# Access Compliance Report

## Public Rights-of-Way

Intersection ID: N/A	Main Street: REA_RD	Cross Street: CEDAR_CROFT_DR	Location: E
ADA ID: BD4D5C98673D	Ramp Type: PerpDiag	Initial Pass/Fail: Fail	Overall Compliance: No
Severity Score: 37.5			
Codes/Mitigation Info/Possible Solution		Field Measurements/Component Compliance

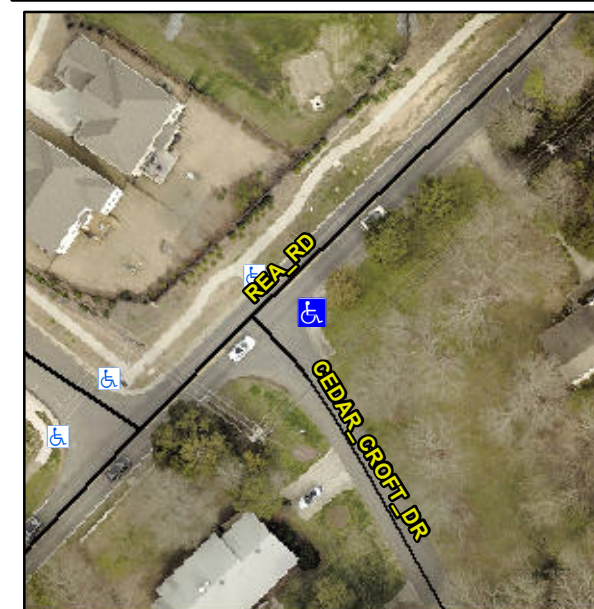
**Not Found, R304.2.2, R304.5.3**

Compliance	Description	Data	Compliance	Description	Data
N/A	Ramp Length (in)	62.0	No	Ramp Slope (%)	11.9
Yes	Ramp Width (in)	48.0	No	Ramp XSlope (%)	10.4
N/A	Flare Type LT	N/A	N/A	Flare Type RT	N/A
N/A	Flare Slope LT (%)	N/A	N/A	Flare Slope RT (%)	N/A
N/A	Flare Traversable LT?	N/A	N/A	Flare Traversable RT?	N/A
N/A	Landing Length (in)	N/A	N/A	DWS Provided?	N/A
N/A	Landing Width (in)	N/A	N/A	DWS Contrast?	N/A
N/A	Landing Slope (%)	N/A	N/A	DWS Length (in)	N/A
N/A	Landing X Slope (%)	N/A	N/A	DWS Full Width?	N/A
N/A	Landing Curb? (Y/N)	N/A	N/A	DWS Offset (in)	N/A
N/A	Shared Landing?	N/A			
N/A	Gutter Ponding?	N/A	N/A	Gutter Slope (%)	N/A
N/A	Gutter Lip Ht (in)	N/A	N/A	Gutter X Slope (%)	N/A
N/A	Painted X Walk1?	No	N/A	Painted X Walk2?	No
	X Walk 1 Direction	To NW		X Walk 2 Direction	To SW
N/A	X Walk 1 Width (in)	N/A	N/A	X Walk 2 Width (in)	N/A
	X Walk 1 Slope (%)	10.1		X Walk 2 Slope (%)	0.2
	X Walk 1 X Slope (%)	3.0		X Walk 2 X Slope (%)	8.9

**Remove & Replace Curb Ramp With Two New Directional Ramps or Equivalent.**
